## Product Change Notice (PCN)

**PCN Number:** PCN-0374226R-01

- CPE 1785

#### ❖ Appearance

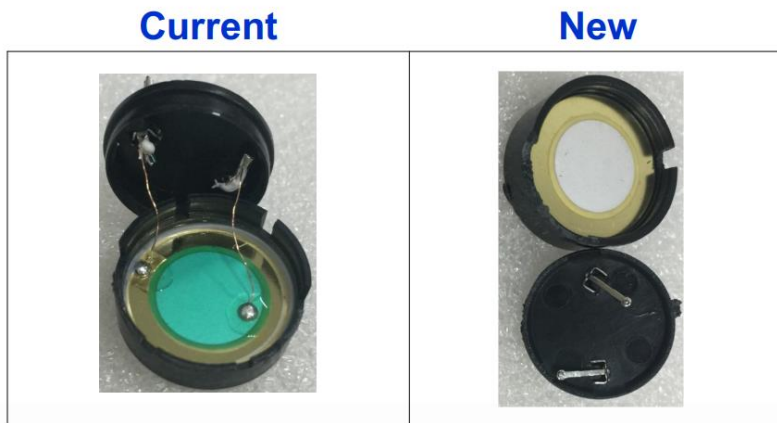
- Case markings Change from NORYL case to PBT
- Bottom notches going from 6 to 2

- ❖ **Inside structure**
  - **Change from solder mask on inside to spring contact**

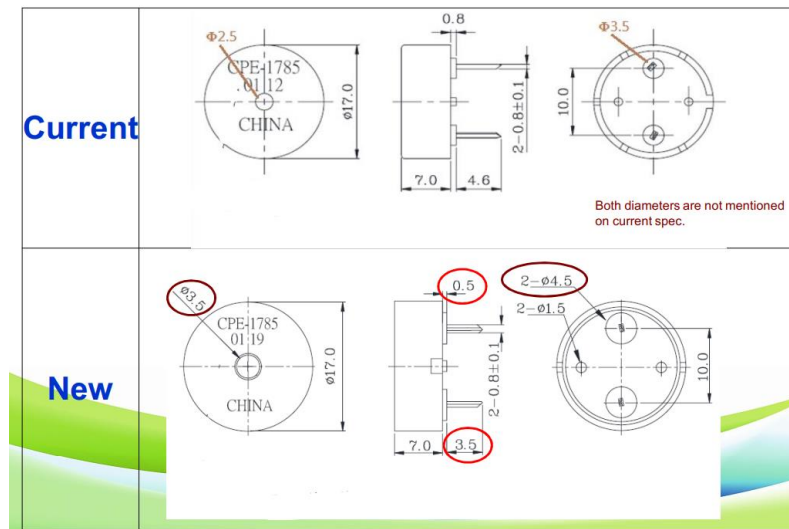
- ❖ **Pin length from 4.6mm to 3.5mm**
